Reference: Engineering Services
55 Wessex Court
Cameron, NC 28326
TE&D Project No.: 2201-020599

- 1) Observation of notched rafters at roof overhang for rear screened-in porch.

Example of notched rafters

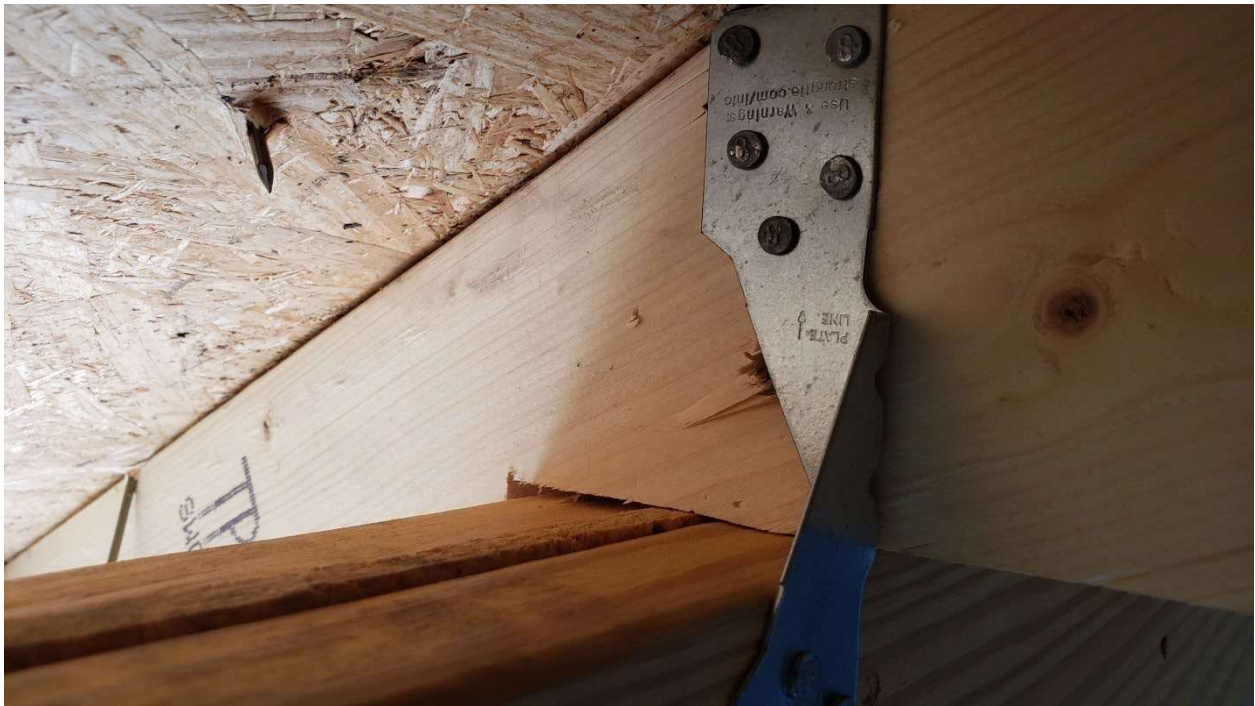
- 1) We observed the 2 x 6 at 16" o.c. rafters as having been notched up to 2-1/2" where the rafters bear at the left and right exterior walls. Based on our observations and analysis, the notched rafters are adequate to support the anticipated loading conditions. No action needed.
